Resubmittal 2

Colby Rezoning and Subdivision
15635 Pecos Street

Please see our responses to each comment inline below, in red:

COLBY SUBDIVISION

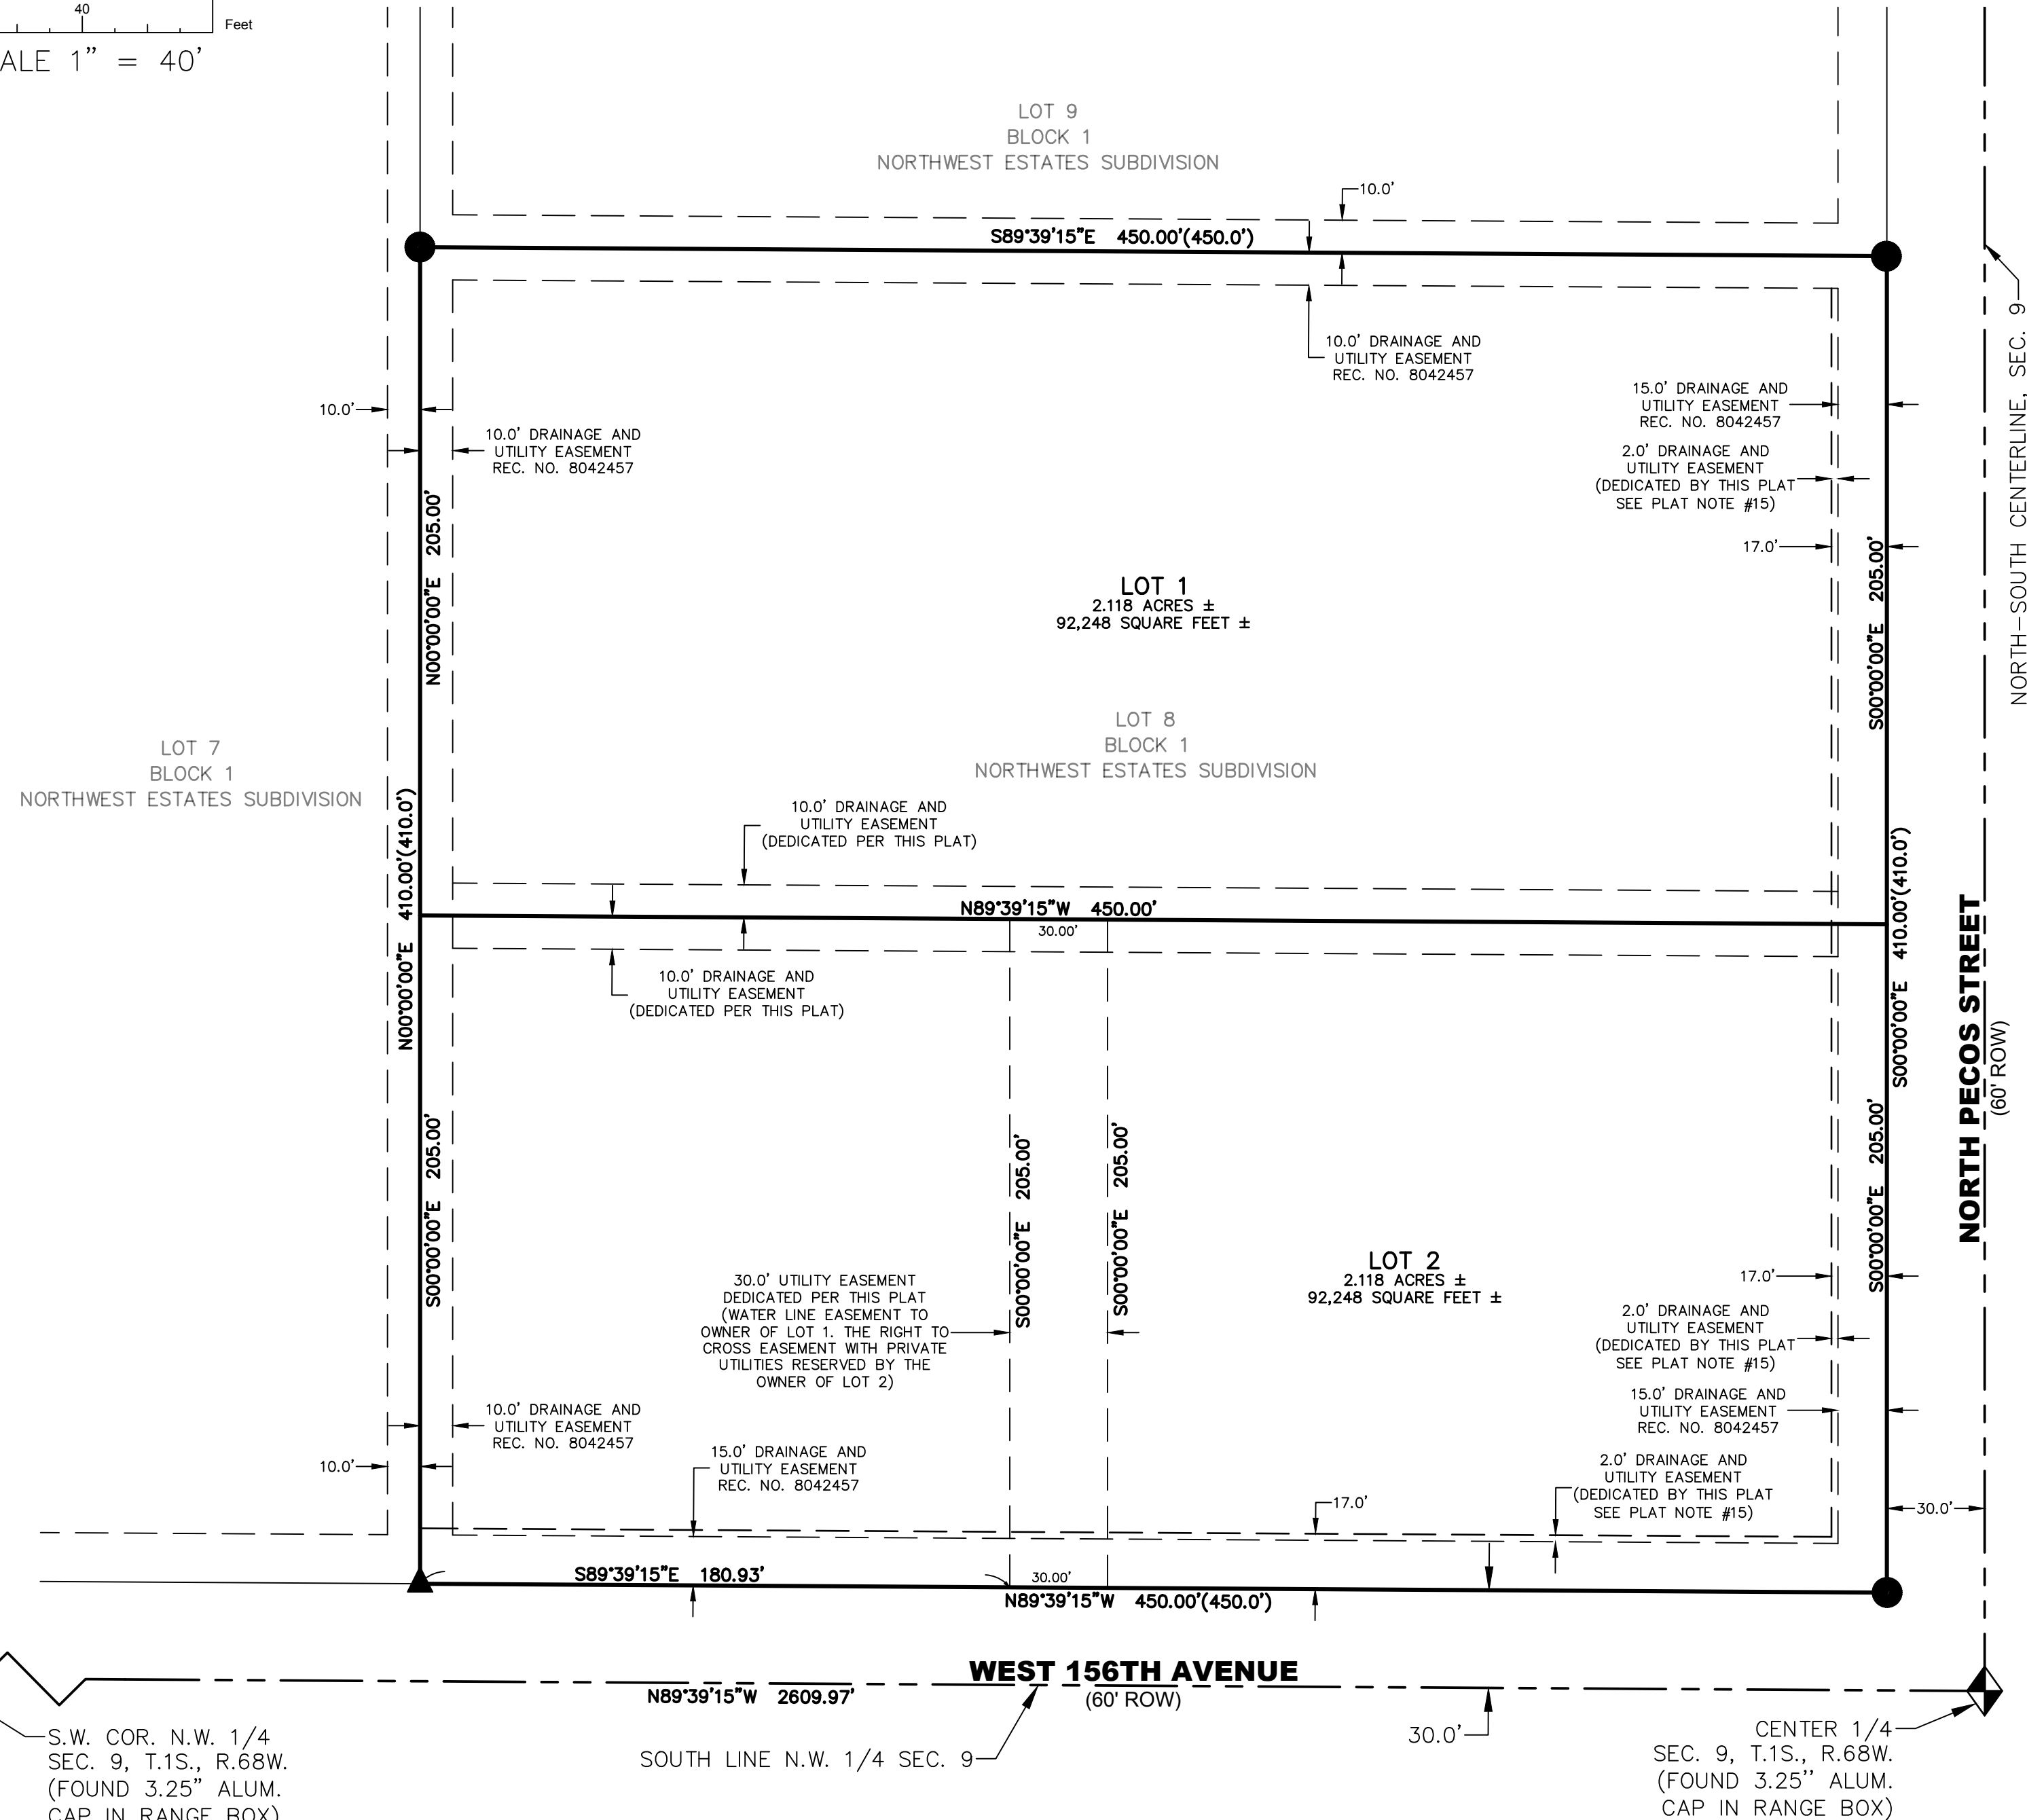
ENV4. The septic system, including its leach field, for each proposed lot will need to be contained within the boundaries of that lot with appropriate setbacks. The design as shown is not permissible with the lot line bisecting the septic field.

Eng1: Engineering redlines are included in the attached, Red-marked Print #2 with comments that needed to be addressed with the next submittal.

See also the updated proposed plat ([pg. 11](#)), which no longer shows the existing septic system, and thus allows for the proposed septic systems to fit, in their entirety, on each proposed lot.

The updated proposed plat ([pg. 11](#)) no longer shows the existing septic system, and thus allows for the proposed septic systems to fit, in their entirety, on each proposed lot.

See updated plat ([pg. 9-11](#)).
